Proposal Request

Project:	Twin Falls Fire Station 2	PR No.:	PR-02
Project No.:	20-041	Date Issued:	May 27, 2022
Owner:	City of Twin Falls 214 Cheney Drive Twin Falls, ID 83301	Issued To:	Starr Corporation 2995 E 3600 N Twin Falls, ID 83301
Contract Date:	April 12, 2022	Attn:	Jason Derricott

ITEM 1: PR-02 Dedication Plaque Design and Room Signage Schedule

1 ROOF FRAMING PLAN
1/8" = 1'-0"

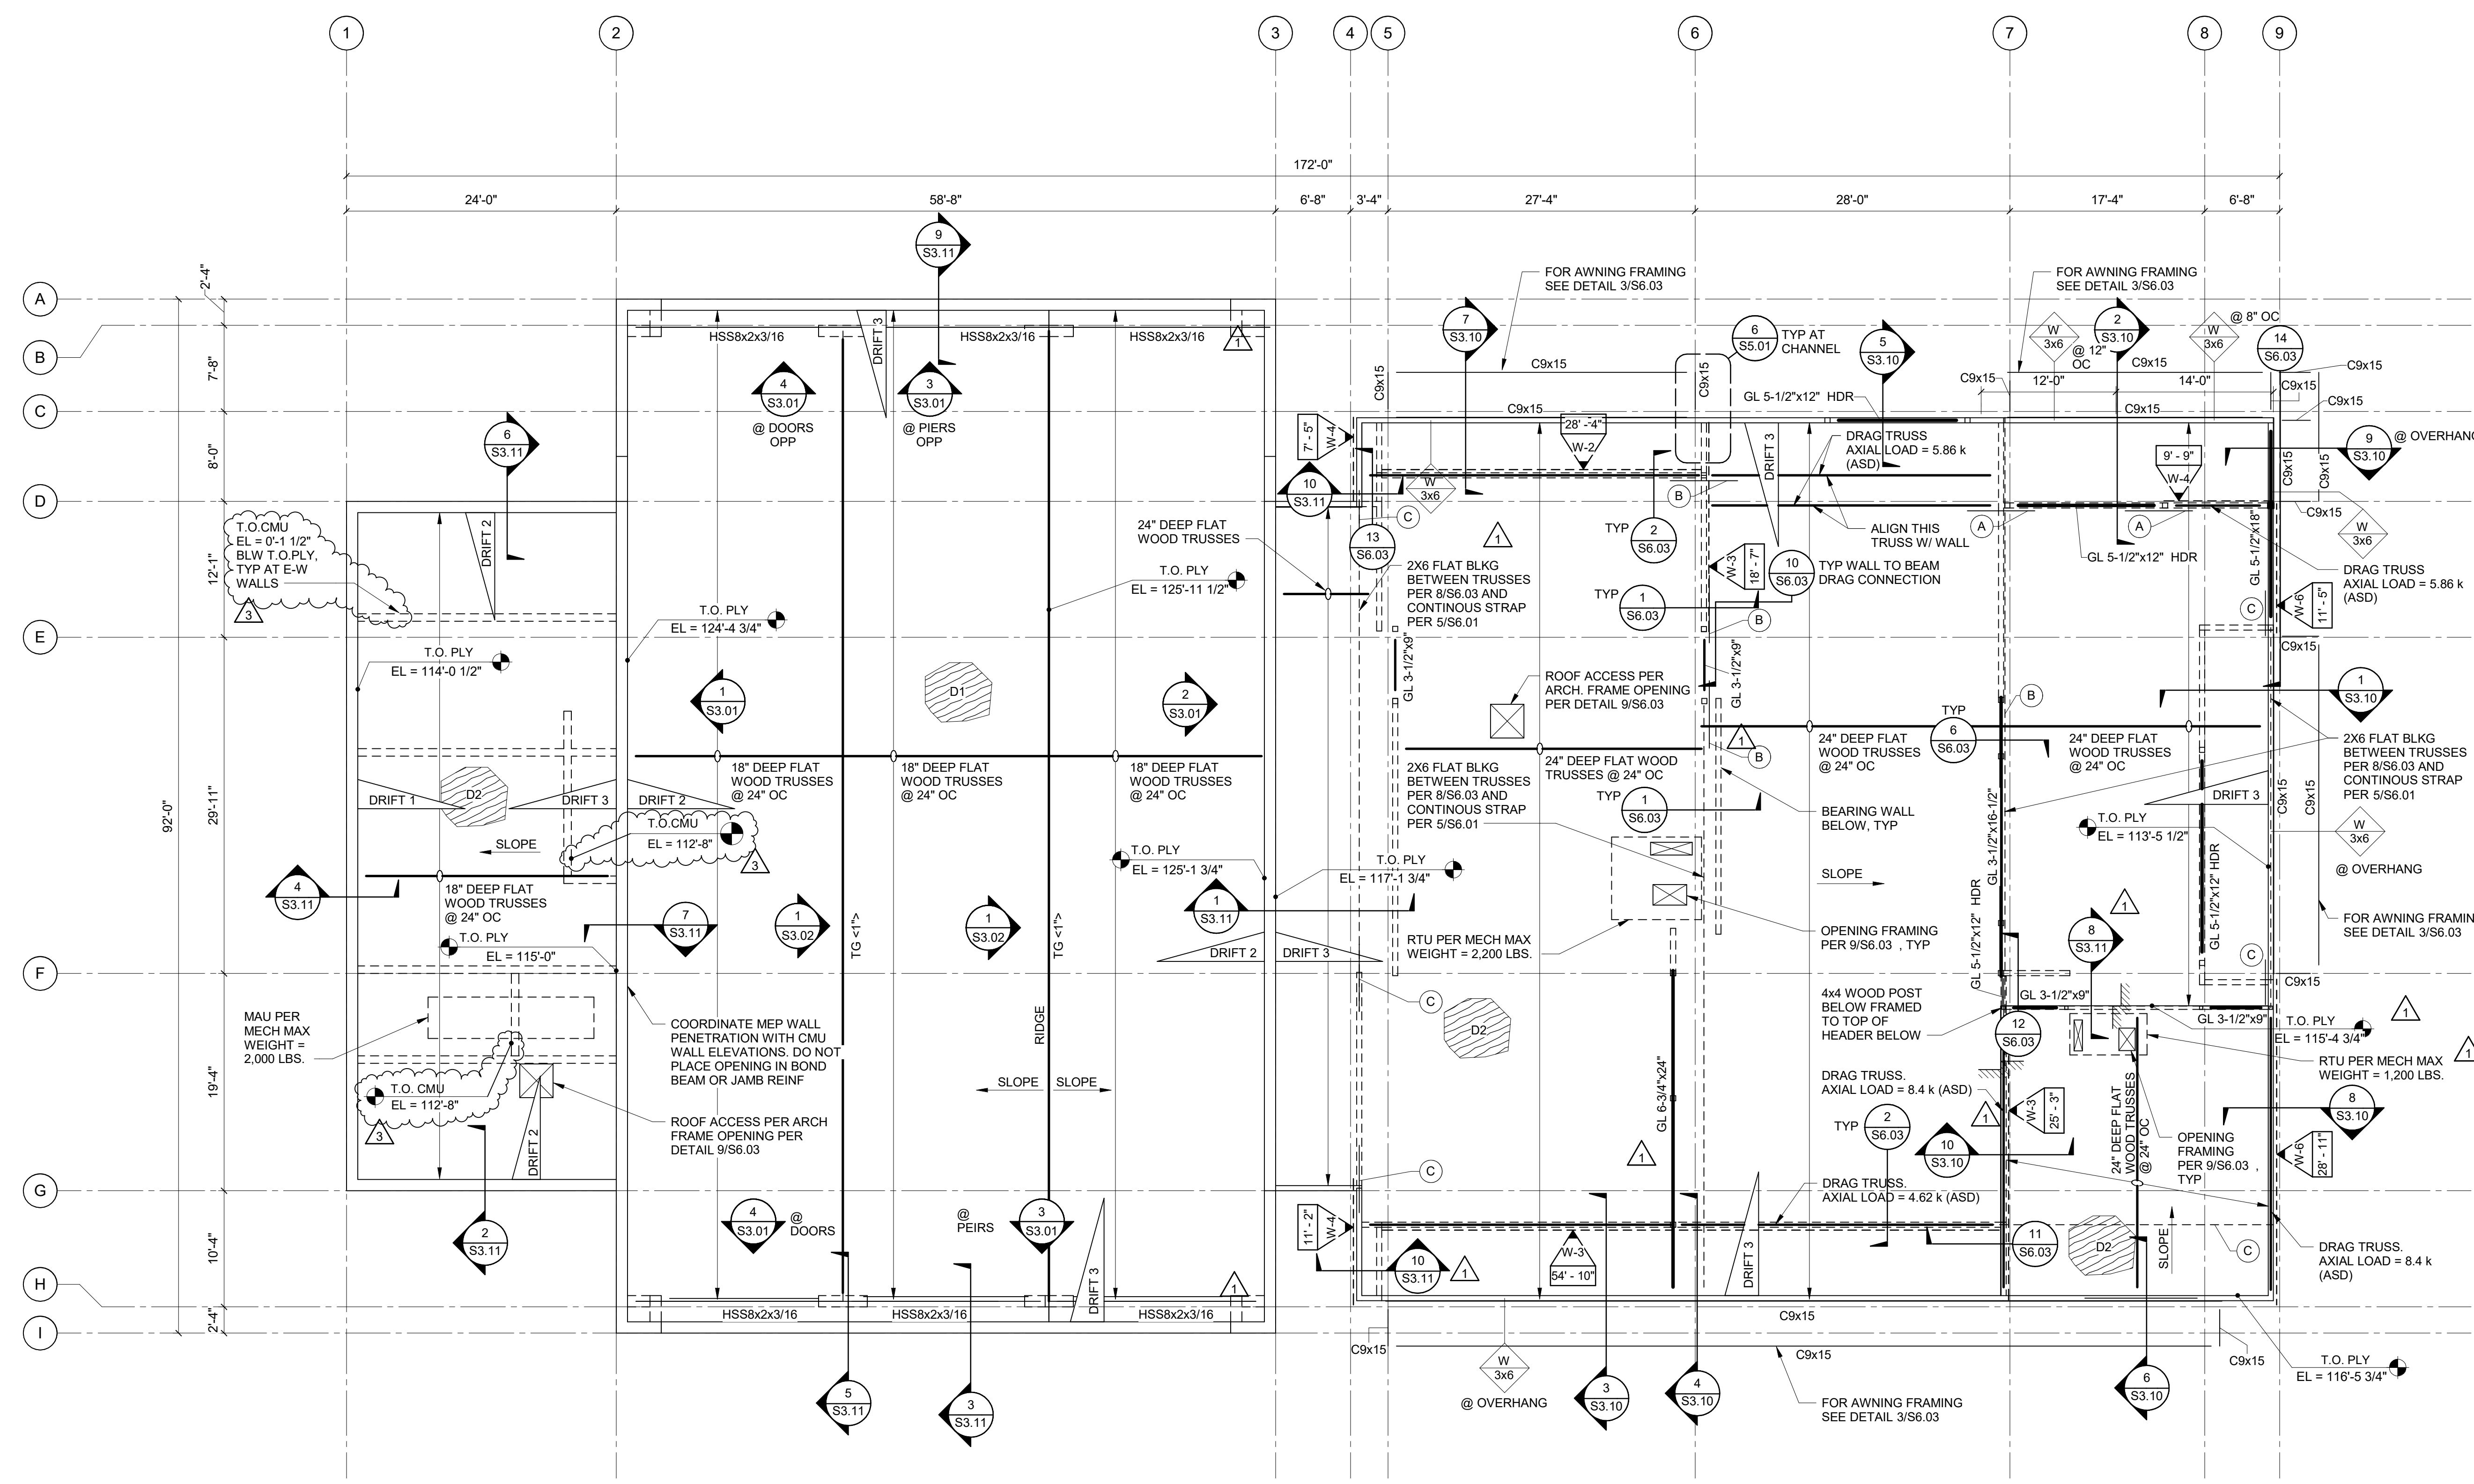
- Provided T.O.CMU elevations for non-bearing CMU Walls.

1 WALL ELEVATION
S3.01 3/16" = 1'-0"

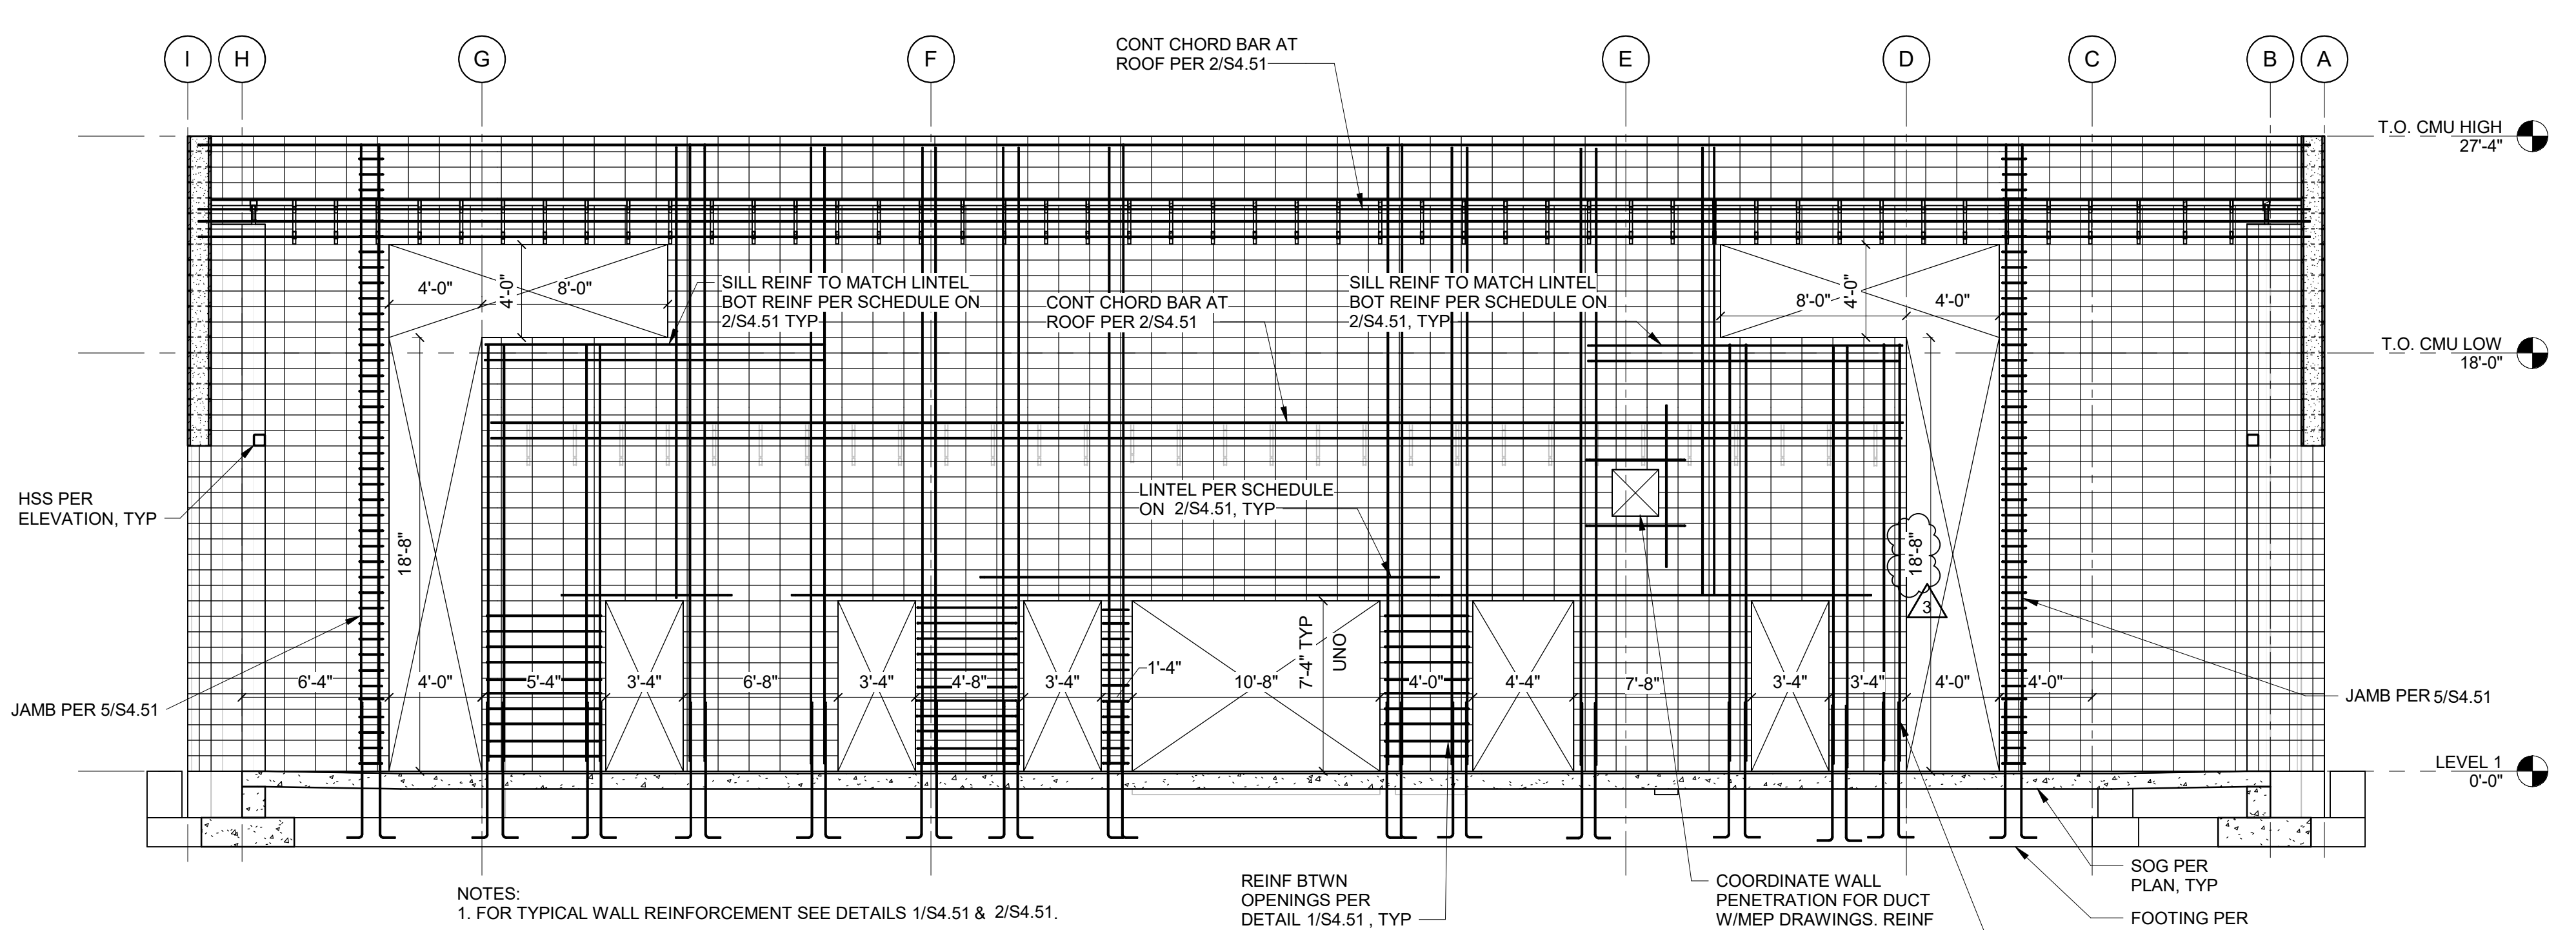
- Detail 1: Replaced the incorrect opening elevation with the correct one.
- Detail 3: Revised the detail callout 5/S5.01 to be clearer.

Sheet Name:
WALL SECTIONS

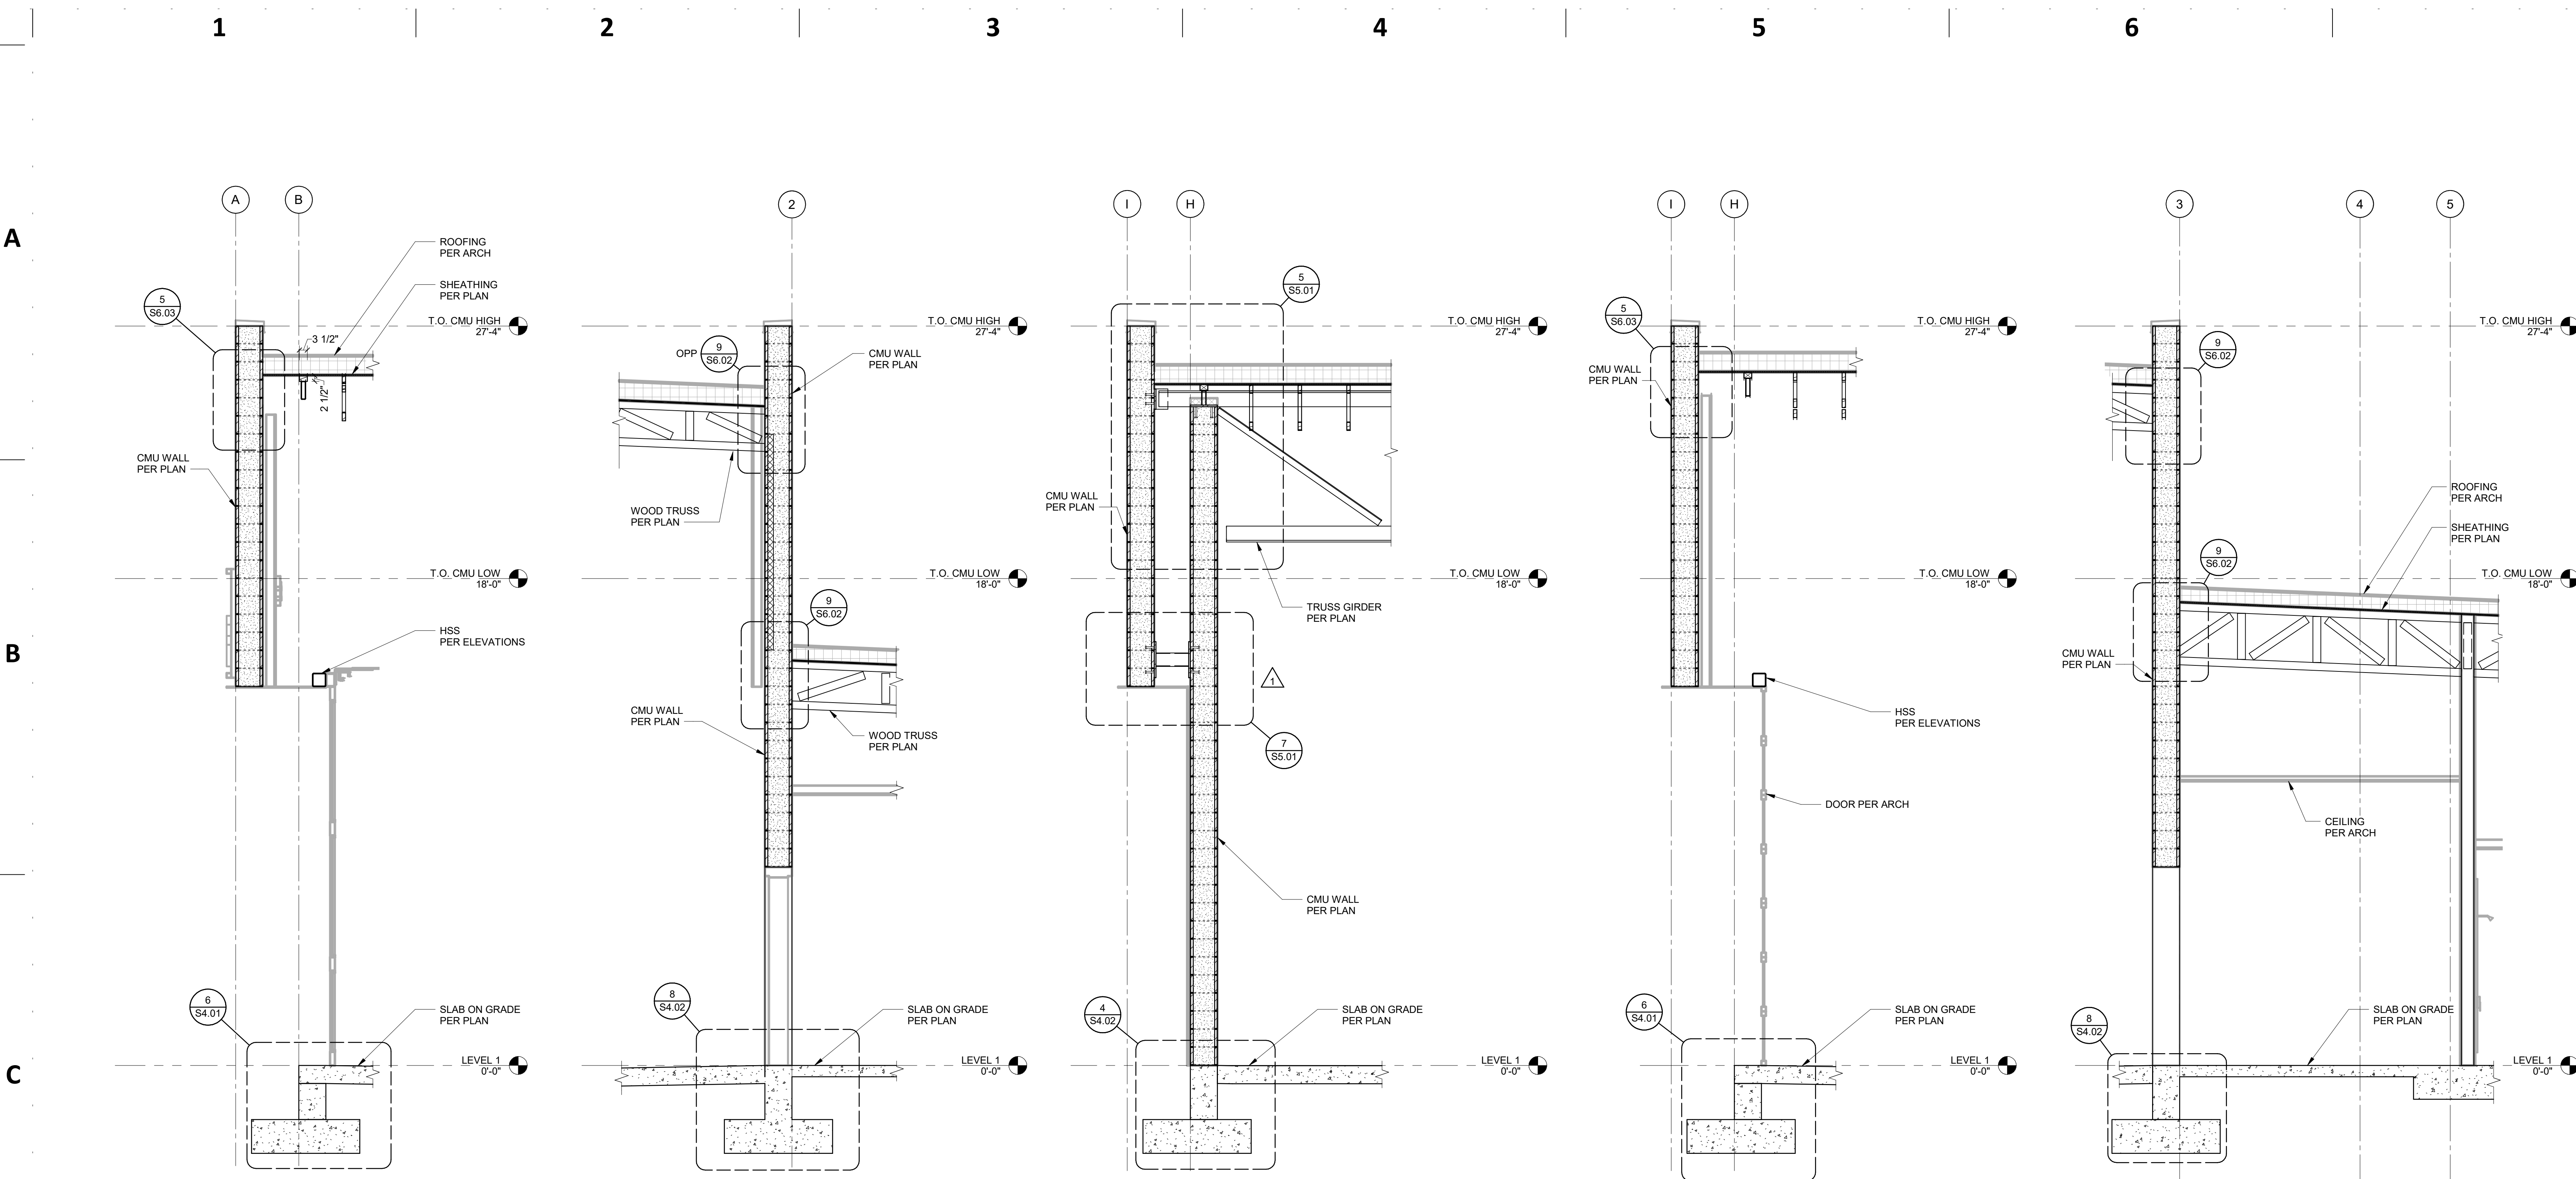
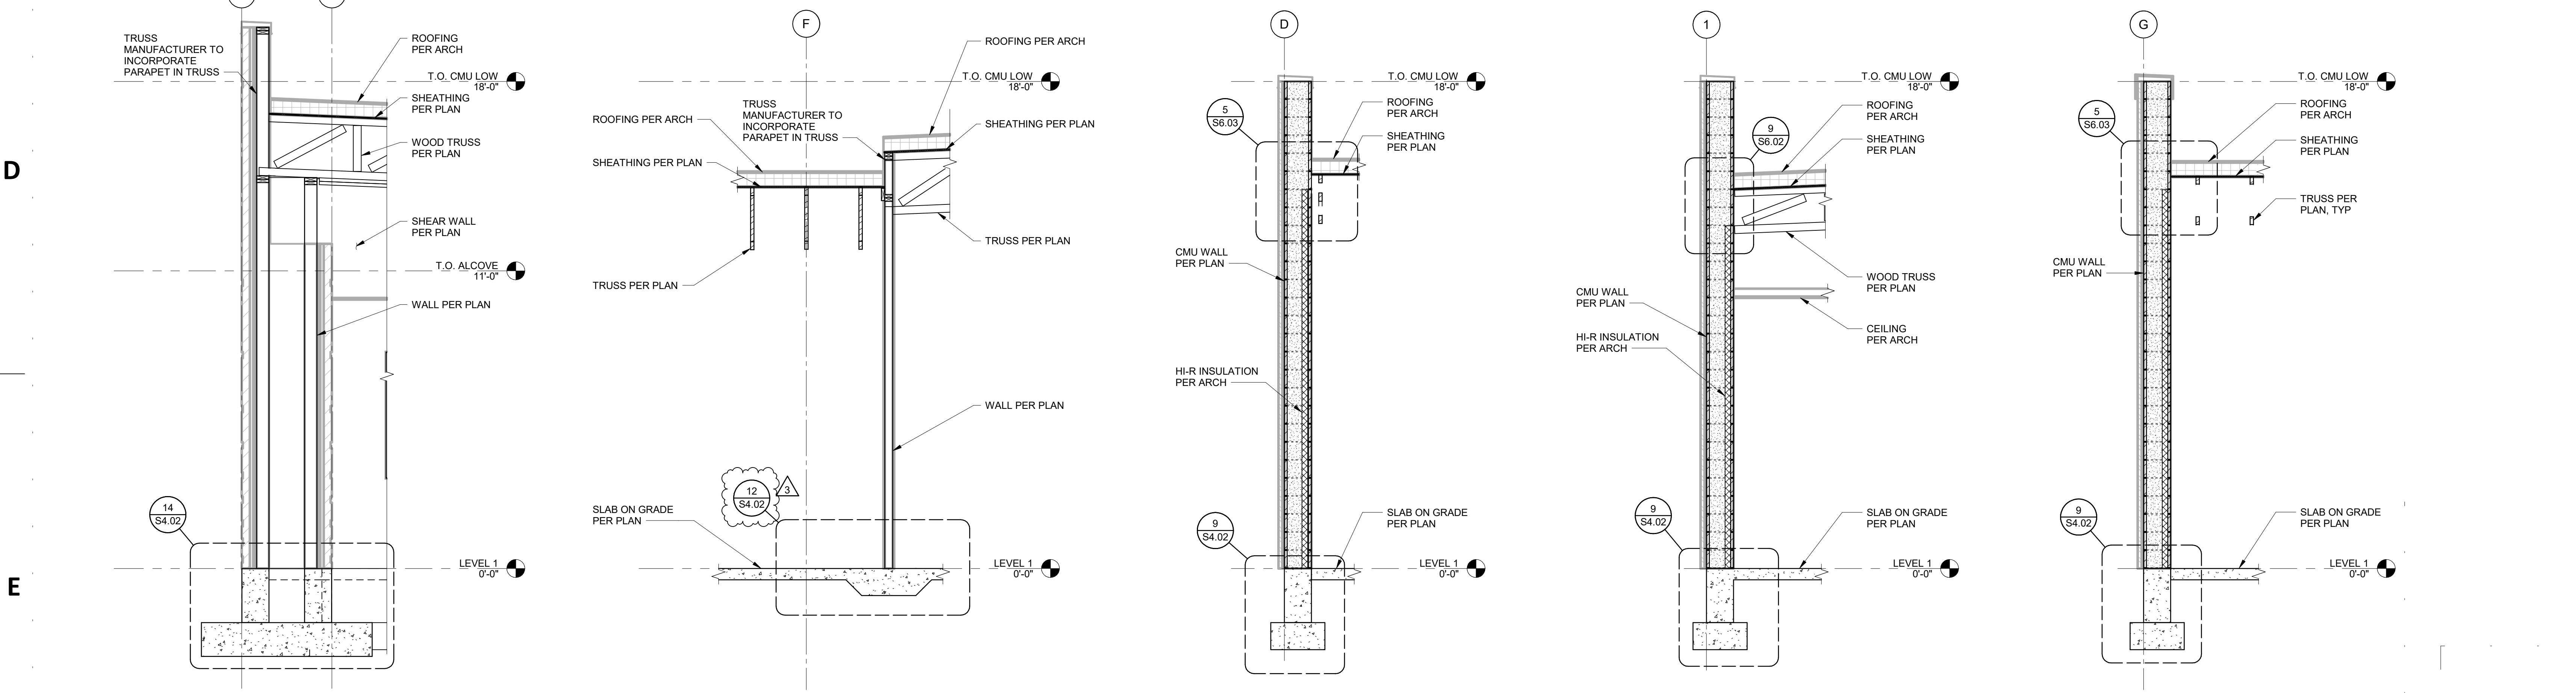
- Detail 8: Replaced the incorrect detail callout with the correct one.
